GFA AD 450
(ISSUE 1)

GFA AIRWORTHINESS DIRECTIVE

TYPE AFFECTED: DG-400 Serial Numbers 4-1 to 4-188.

SUBJECT: Engine extension/retraction drive.

Instructions for the modification of the spindle drive

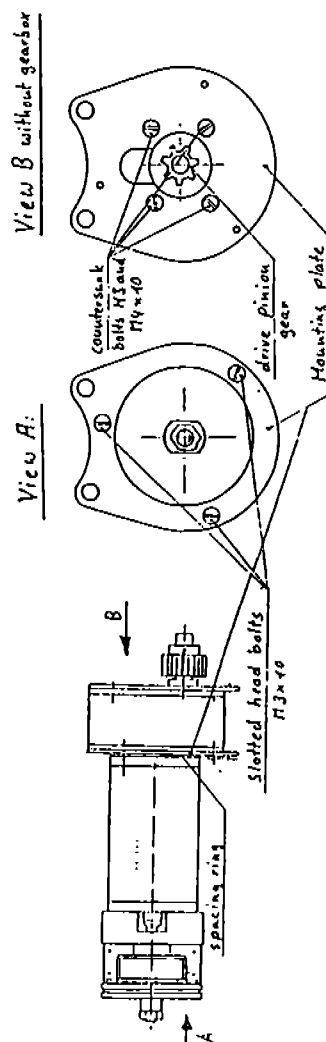
Procedure 4: Modification of the spindle-drive.
The mounting plate between the spindle motor and the gearbox has to be replaced in order to reduce the amount of free-play between the drive gear and the gearbox.

1. Remove the three slotted-head bolts (#3) on the underside of the separator plate and then remove the gearbox.

2. Unscrew the four countersunk bolts (two are M3 and two are M4) in order to remove the old mounting plate from the spindle motor. The old mounting plate and the spacing ring can be discarded as they are no longer required.

3. Check the motor's exposed drive gears for signs of damage (broken teeth, excessive wear etc.). If the gears are damaged, a replacement motor can be obtained from Glaser-Dirks.
4. The new mounting plate is reassembled using three round head bolts (M 3 x 10 DIN 964 Stzn) instead of the slotted-head bolts (M 3).

Reassemble the gearbox and re-attach the spindle motor by reversing the steps used to removed them. Leave away the washers below the M6 locknuts of the two M6 x 50 bolts. Reconnect the cables to the spindle motor (Connect No. 75 - No. 751, No. 76 - No. 761) and insulate with heat-shrink tubing (as described below). The heat-shrink tubing must be heated with a heat-gun or a soldering iron in order to shrink it tightly around the connectors.
